Access Compliance Report

Public Rights-of-Way

(Curb Ramps)

Intersection ID: 3237	Main Street: HERITAGE_HILLS_LN	Cross Street: MACKINAC_ST	Location: SW
ADA ID: CACE1BB6EF87	Ramp Type: Perp	Initial Pass/Fail: Fail	Overall Compliance: No
Severity Score: 8.75			
Codes/Mitigation Info/Possible Solution		Field Measurements/Component Compliance

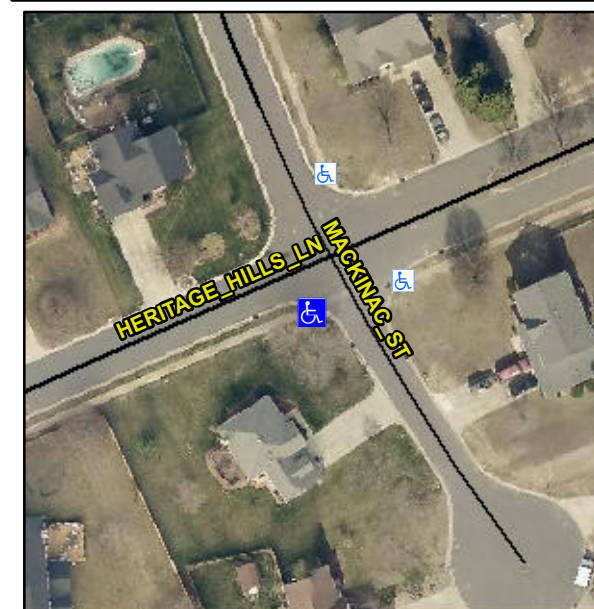
Compliance	Description	Data	Compliance	Description	Data
N/A	Ramp Length (in)	48.0	Yes	Ramp Slope (%)	8.0
No	Ramp Width (in)	46.5	Yes	Ramp XSlope (%)	0.5
N/A	Flare Type LT	N/A	N/A	Flare Type RT	N/A
N/A	Flare Slope LT (%)	N/A	N/A	Flare Slope RT (%)	N/A
N/A	Flare Traversable LT?	N/A	N/A	Flare Traversable RT?	N/A
N/A	Landing Length (in)	N/A	N/A	DWS Provided?	N/A
N/A	Landing Width (in)	N/A	N/A	DWS Contrast?	N/A
N/A	Landing Slope (%)	N/A	N/A	DWS Length (in)	N/A
N/A	Landing X Slope (%)	N/A	N/A	DWS Full Width?	N/A
N/A	Landing Curb? (Y/N)	N/A	N/A	DWS Offset (in)	N/A
N/A	Shared Landing?	N/A			
N/A	Gutter Ponding?	N/A	N/A	Gutter Slope (%)	N/A
N/A	Gutter Lip Ht (in)	N/A	N/A	Gutter X Slope (%)	N/A
N/A	Painted X Walk1?	No	N/A	Painted X Walk2?	N/A
	X Walk 1 Direction	To E		X Walk 2 Direction	N/A
N/A	X Walk 1 Width (in)	N/A	N/A	X Walk 2 Width (in)	N/A
	X Walk 1 Slope (%)	0.2		X Walk 2 Slope (%)	N/A
	X Walk 1 X Slope (%)	1.3		X Walk 2 X Slope (%)	N/A

N/A	Ramp inside XWalk1?	N/A	N/A	Ramp inside XWalk2?	N/A
	Road Slope (%)	N/A	N/A	Clear Space?	N/A
	Road X Slope (%)	N/A	N/A	Clear Space to XWalk (in)	N/A
N/A	Any Obstructions?	N/A	N/A	Storm Grate/Utility Hazard?	N/A
	Obstruction Type			Storm Grate/Utility Type	
		N/A			N/A
		Yes		Surface Condition? (G/P)	Good

Remove & Replace Entire Ramp.

R304.5.1
